SQ Celsius Limited (Unit 04)

Plot No CS 224, 225, 242 & 243 Jamirdia, Bhaluka, Mymensingh

29 April 2026

Observation-10: Damaged rack member. [Warehouse Shed]

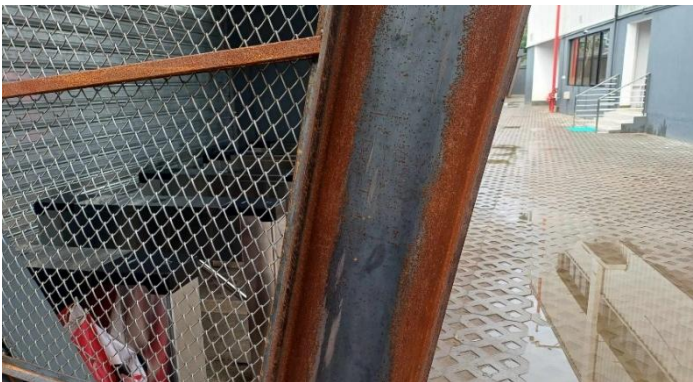
Description: During the inspection, a rack member was found damaged. The factory is required to Repair the damaged rack member with a suitable method or replace it if required.

14.		Carry out remedial work if required.	within 6 months
15.	Damaged rack member. [Warehouse Shed]	Repair the damaged rack member with suitable method or replace it if required.	within 6 weeks
